City of NAPOLEON, OHIO

Re: 210 W. Maumee

RESIDENTIAL PLAN CORRECTION SHEET

ADDENDUM TO PERMIT NO. 01708-11

7 F3-19C
SCALE= 4/16
JT TYPE W LEN Y X (MEMBER)

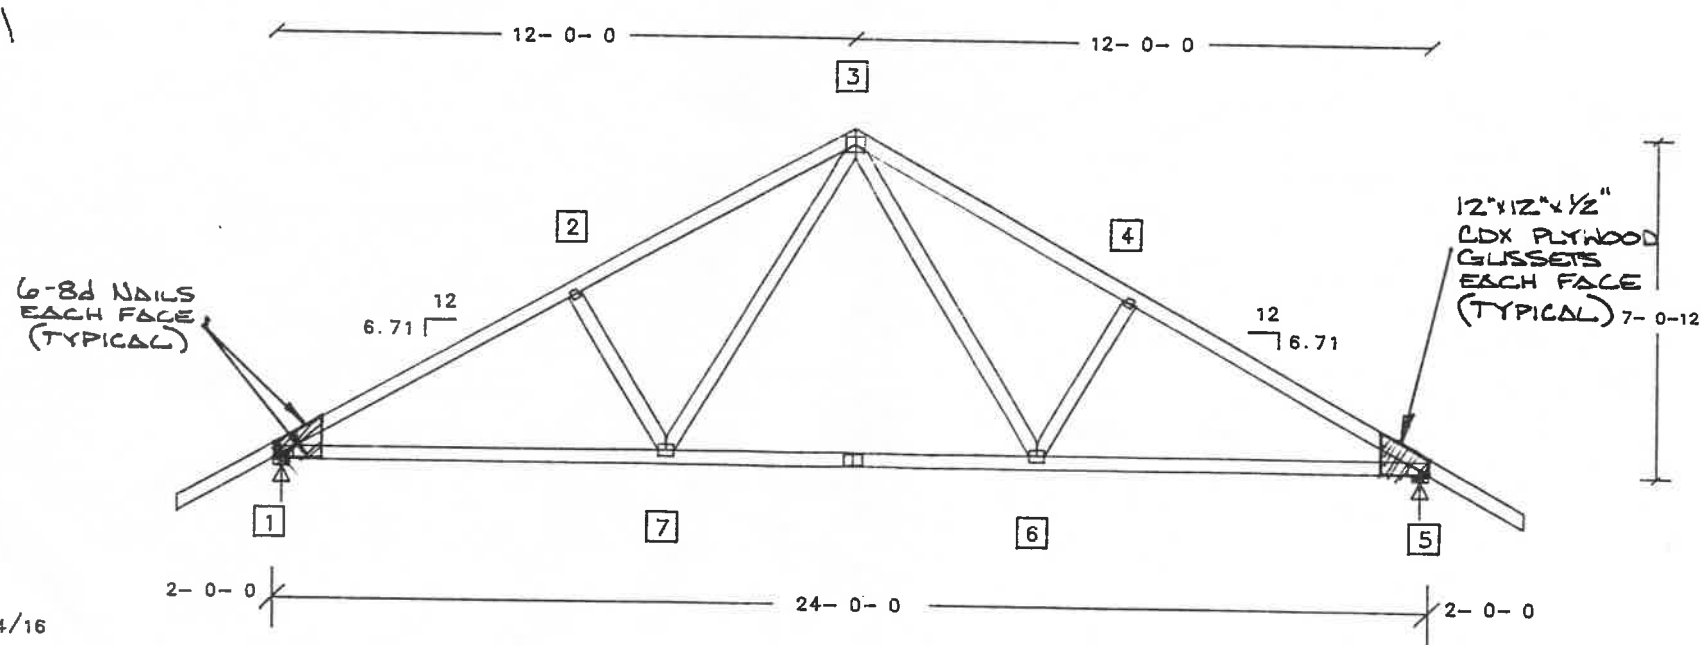
PROBLEM: THE TRUSS NEEDS
TO BE REINFORCE TO SUPPORT
AN ADDITIONAL 10 PSF BOTTOM
CHORD LIVE LOAD.

SOLUTION: NAIL 1/2" CDX PLYWOOD
GUSSETS TO EACH FACE AS SHOWN.
